Groundwater Application Review Summary Form

Application # G- 18695

To: Kristopher Byrd, Well Construction and Compliance Section Manager
From: Joel Jeffery, Well Construction Program Coordinator
Subject: Review of Water Right Application G-18695
Date: May 28, 2019

PUBLIC INTEREST REVIEW FOR GROUNDWATER APPLICATIONS

Figure 2. Well Location Map

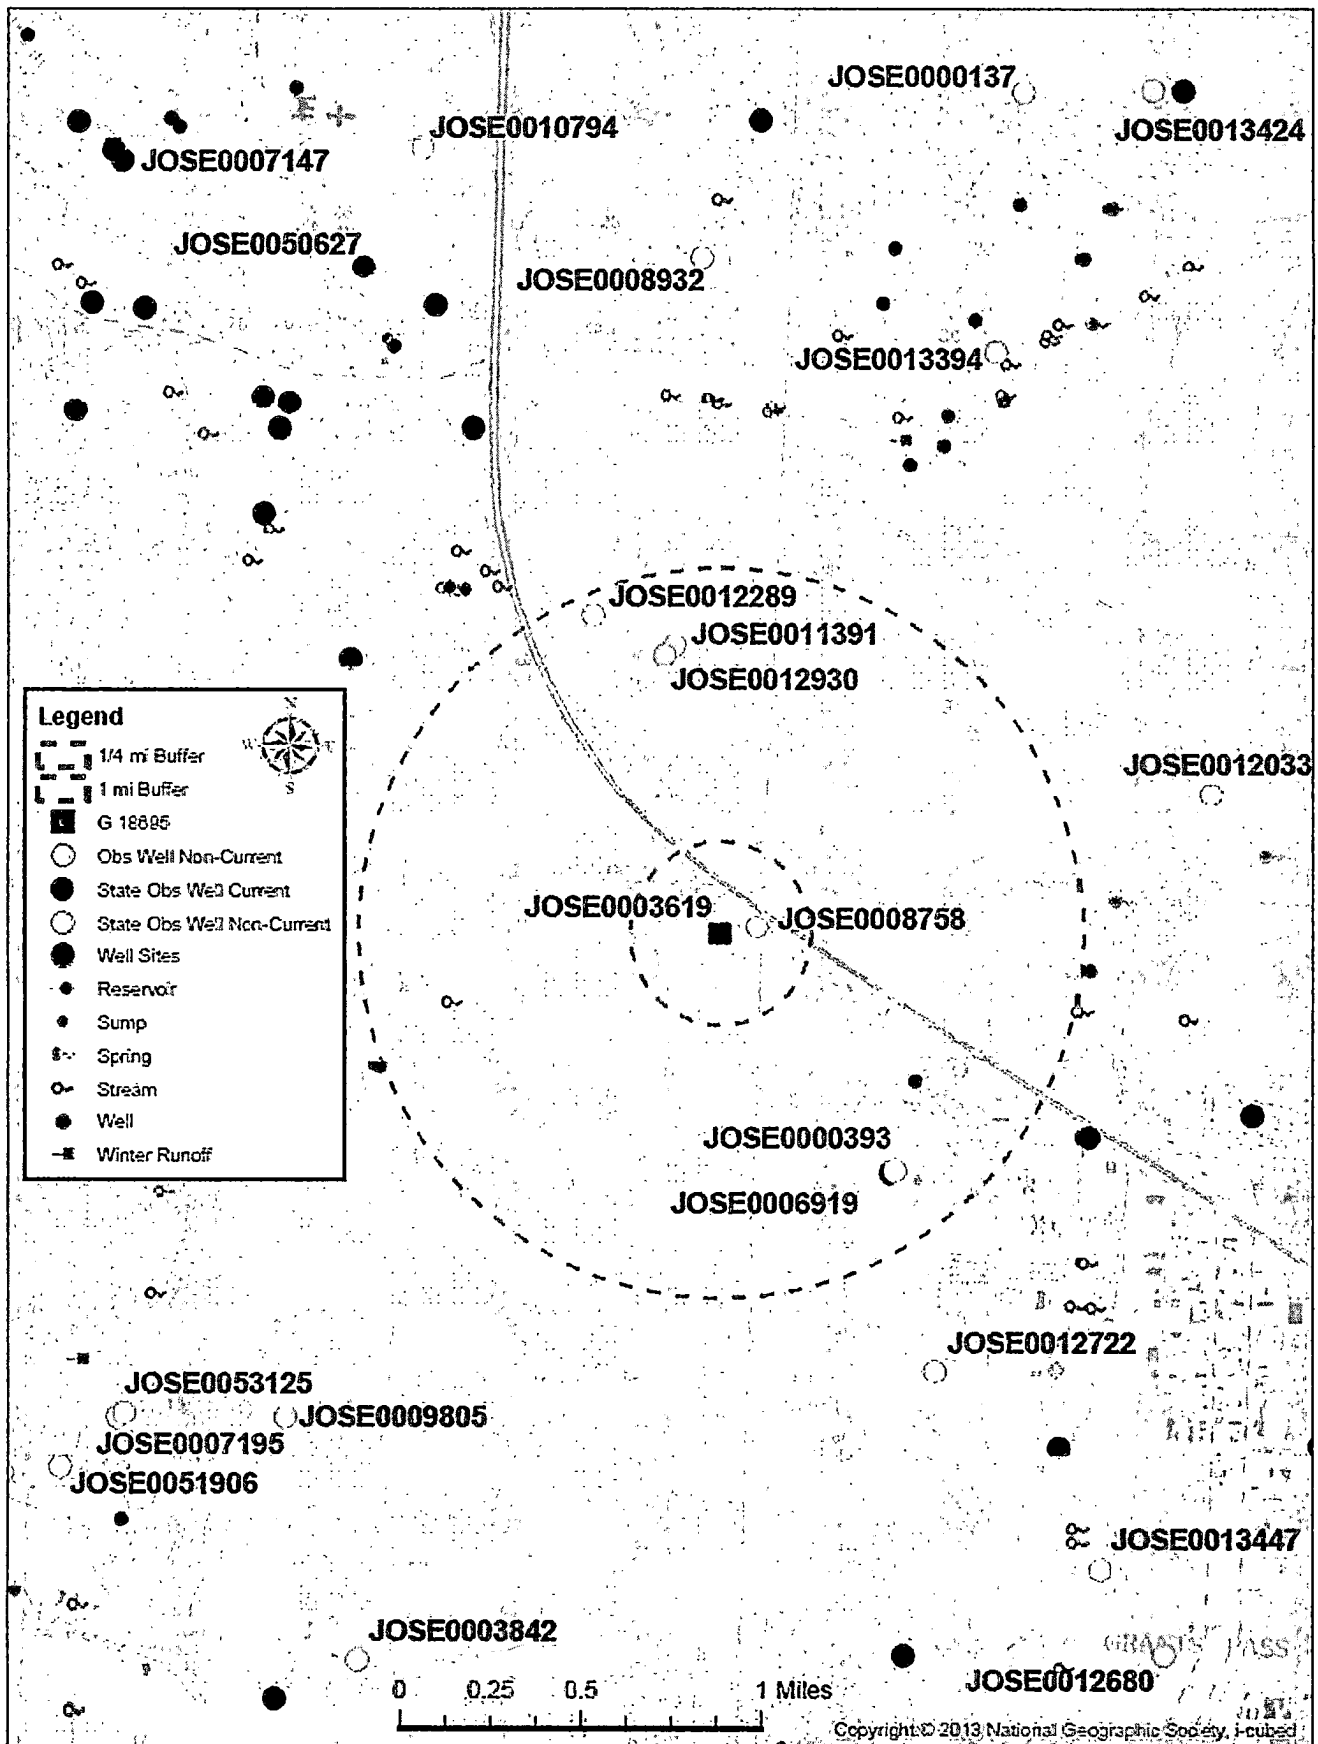
A4. **Comments:** The application map gives metes and bounds for the well as 100' S and 664' E from the NW corner of section 5. The measurement is actually from the NW corner of the owner's taxlot, so the applicant will need to submit an amended application map with metes and bounds from a PLS corner. The TRSq is correct.
